UNITED STATES PATENT AND TRADEMARK OFFICE

APPLICATION NO.	FILING DATE	FIRST NAMED INVENTOR	ATTORNEY DOCKET NO.	CONFIRMATION NO.
10/506,757	03/31/2005	Leonard Borgstrom	6485-0042WOUS	8919

Office Action Summary

FINAL OFFICE ACTION

FIG. 6

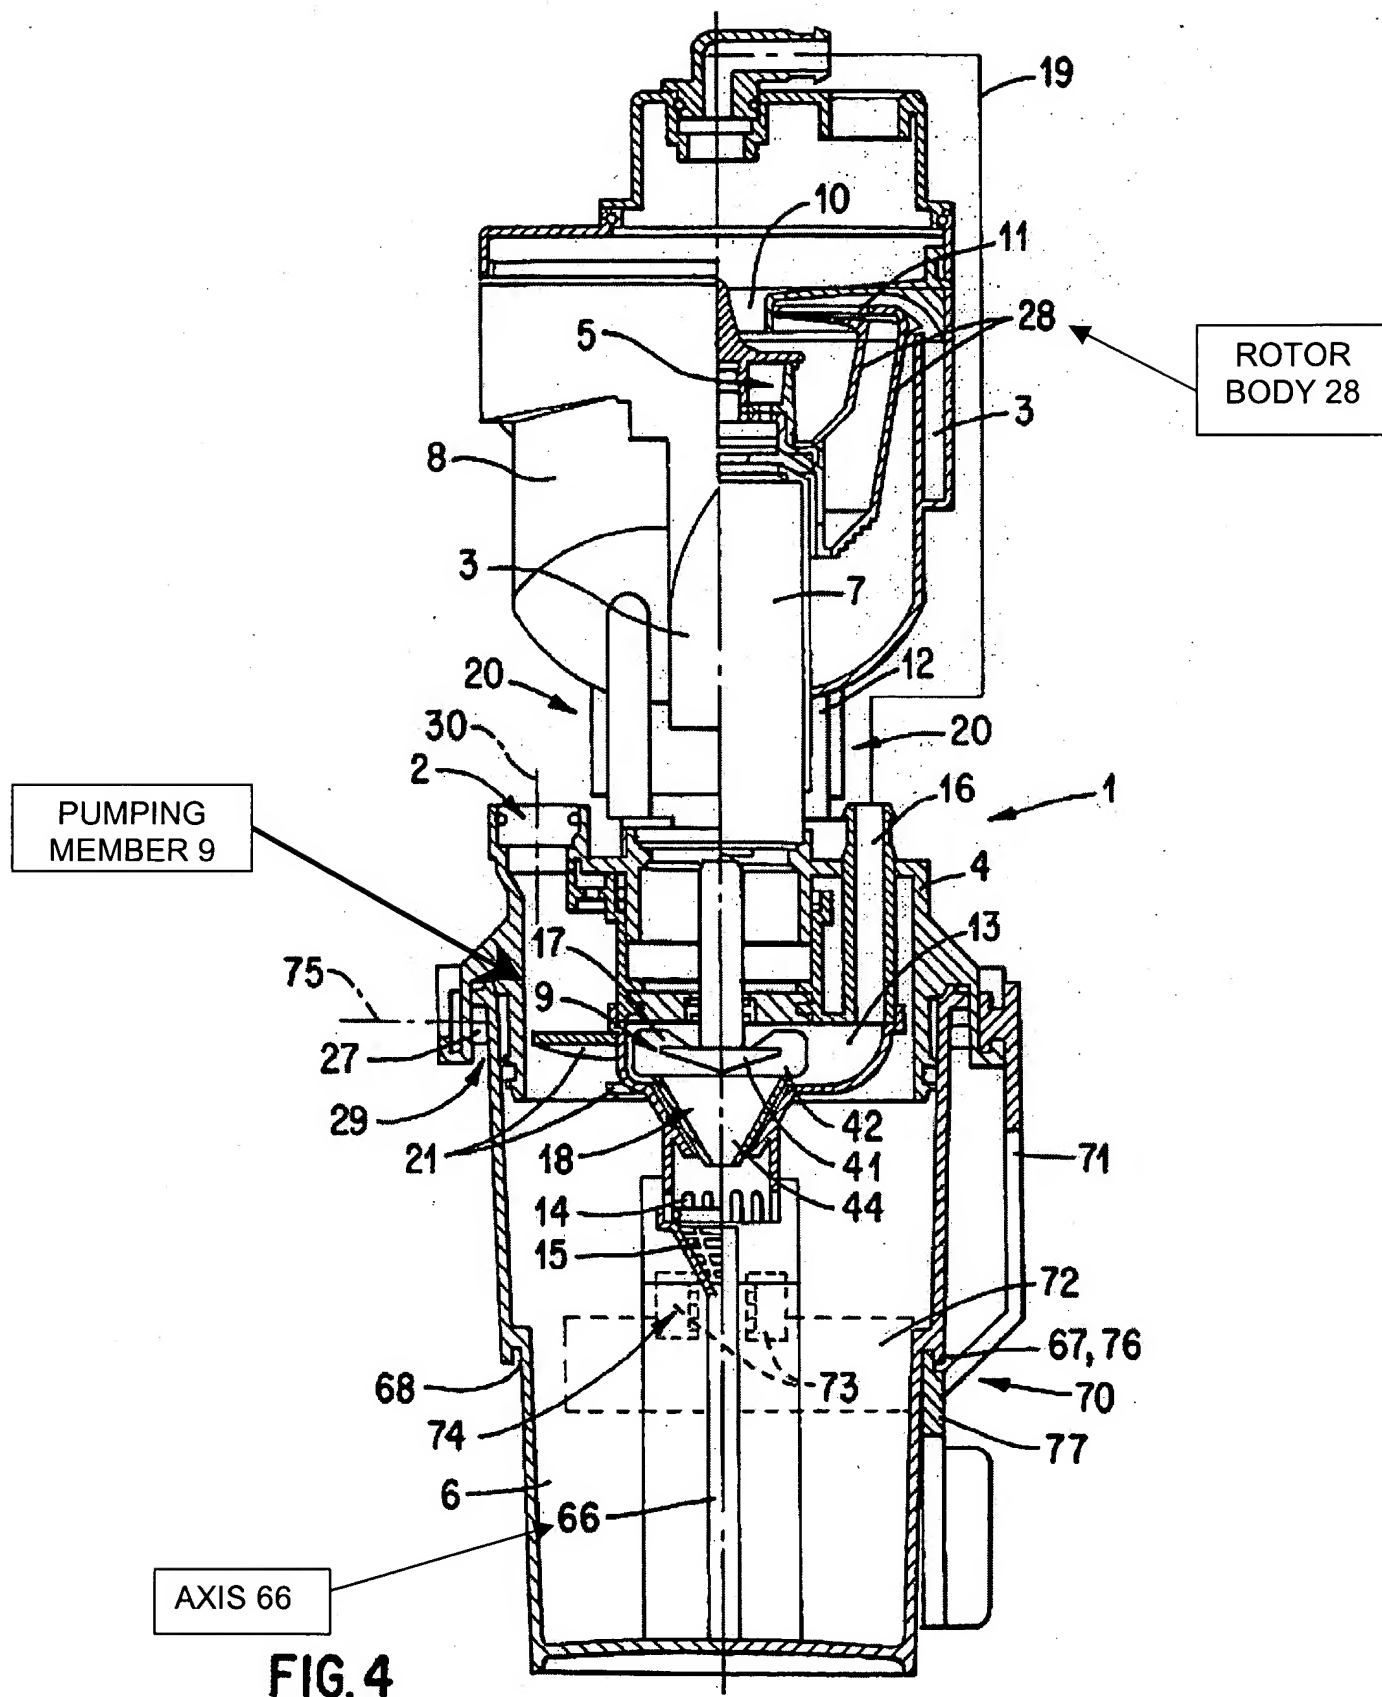
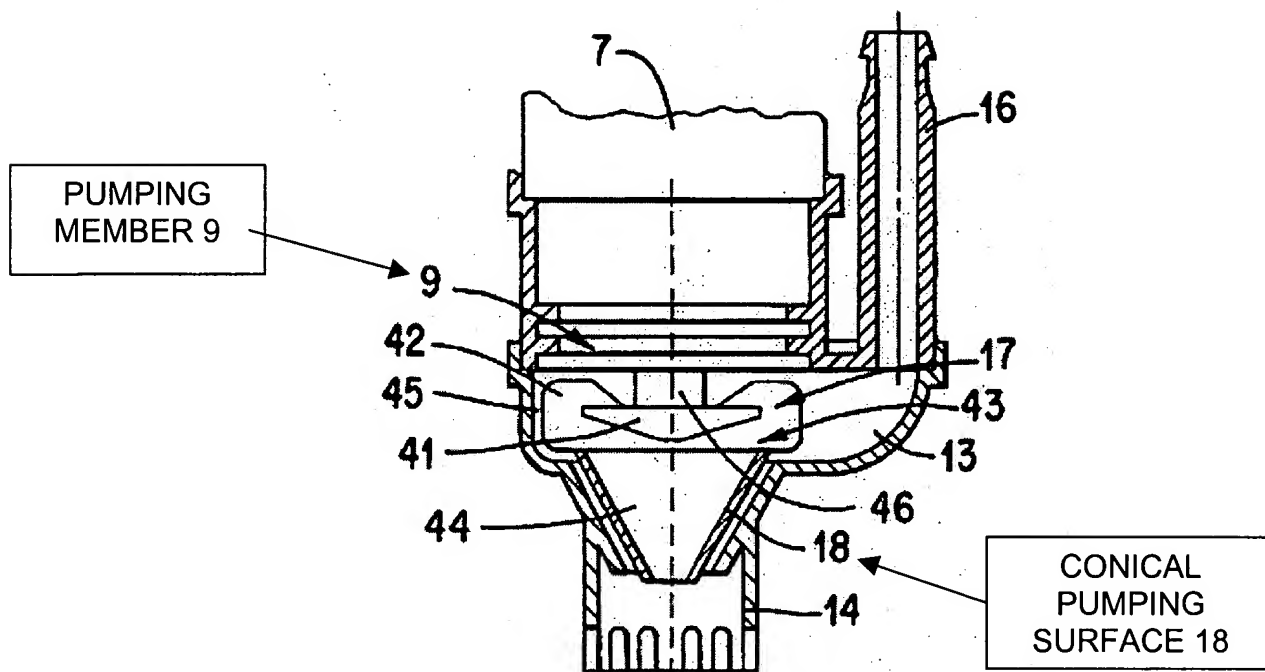
The patent to TRAWOGER '282 discloses a centrifugal separator 1 including a centrifugal rotor 5 arranged for rotation around a substantially vertical rotational axis 66, the centrifugal rotor having a rotor body 28 delimiting a separation chamber, and a pumping assembly 9 (shown in Fig. 6 as including rotating and stationary elements thereof), the pumping assembly 9 having a rotating member 17, 18 that is arranged to rotate with the rotor body and a member 14 arranged to extend during the operation of the centrifugal rotor downwardly from the rotor body and into a liquid body 6, situated under the rotor body, for pumping of liquid from the liquid body into the rotor body, the pumping member 9 having on an outside thereof, a pumping surface 18 facing away

from the rotational axis, extending mainly rotational-symmetrically around the rotational axis and being arranged to have contact with a free liquid surface on said liquid body in an area extending around the pumping member, the pumping surface 18 on the outside of the pumping member, at least along a part of the axial extension of the pumping member in said area, having a generatrix forming an angle within the recited range with respect to the rotational axis 66 such that the pumping member along said part of its axial extension defines increasing diameter from below and upwards as seen in Figs. 4 and 6, so that upon rotation of the rotor liquid will flow upwards from the free liquid surface on the outside of the pumping member 9, and wherein the rotor delimits a receiving space proximate 10 situated so that it receives liquid that upon rotation of the rotor has been brought to flow upwards from the free liquid surface on the outside of the pumping member 9; wherein means 11 are arranged to maintain a free liquid surface in the separation chamber of the centrifugal rotor at a first radial distance from the rotational axis 66, said receiving space communicating with the separation chamber at a second radial distance from the rotational axis greater than the first radial distance; wherein a driving device 7 for rotation of the centrifugal rotor supports the pumping member and the rotor body; the separation chamber has two outlets (3 and/or 11) and 12 at different radial distances from the rotational axis 66 of the rotor for the respective separated phases of different densities with all of the recited structure being depicted in the Figures below:

Applicant's primary argument is that the pumping member of TRAWOGER '282 never contacts a free liquid surface. Applicant does not assert that the pumping member of TRAWOGER '282 is structurally dissimilar from the claimed invention, but merely the relationship of the pumping member to free liquid surface of the material being processed (or worked upon - i.e., the liquid to be separated). This argument is not found persuasive because with regard to apparatus claims versus method claims, in apparatus claims the material or article worked upon (i.e., the body of liquid being separated by centrifuge or a free surface thereof) does not limit the claimed apparatus and is not a major consideration when determining the patentability of said apparatus claims (MPEP 21 15). "Expressions relating the apparatus to contents thereof during an intended operation are of no significance in determining patentability of the apparatus claim." *Ex parte Thibault*, 164 USPQ 666, 667 (Bd. App. 1969). Furthermore, "[i]nclusion of material or article worked upon by a structure being claimed does not impart patentability to the claims." *In re Young*, 75 F.2d 966, 25 USPQ 69 (CCPA 1935) (as restated in *In re Otto*, 312 F.2d 937, 136 USPQ 458, 459 (CCPA 1963)). The examiner

also notes the claims are devoid of any structure to contain the body of liquid (such as a vessel or tank) or any means to control the level of liquid such that the free liquid surface is maintained at a particular level with respect to the pumping member.

It also may be reasonable to declare the relationship of the centrifuge to the material being worked upon (which again is not germane to the patentability of the centrifuge itself) is but an intended use of the centrifuge. Such an intended use has not been afforded any patentable weight because it has been held that a recitation with respect to the manner in which a claimed apparatus is intended to be employed does not differentiate the claimed apparatus from a prior art apparatus satisfying the claimed structural limitations. *Ex parte Masham*, 2 USPQ2d 1647; *In re Sebald*, 122 USPQ 527; *In re Lemin et al.*, 140 USPQ 273; *In re Sinex*, 135 USPQ 302; *In re Pearson*, 181 USPQ 641. It is well settled that the intended use of an apparatus is not germane to its patentability. *In re Self*, 671 F.2d 1344, 213 USPQ 1 (CCPA 1982); *In re Yanush*, 477 F.2d 958, 177 USPQ 705 (CCPA 1973); *In re Finsterwalder*, 436 F.2d 1028, 168 USPQ 530 (CCPA 1971); *In re Casey*, 370 F.2d 576, 152 USPQ 235 (CCPA 1967). Thus, whether the centrifuge is at a location remote from the free liquid surface, is just above the surface, or immersed below the surface does not impact the patentability of the centrifuge itself. Note claims 14 and 15 are allowed not because of the recitations regarding the liquid, but rather because TRAWOGER '282 does not teach or suggest the recited structural relationships between the rotor and pumping surface as the rotor and pumping member are axially spaced or separated.
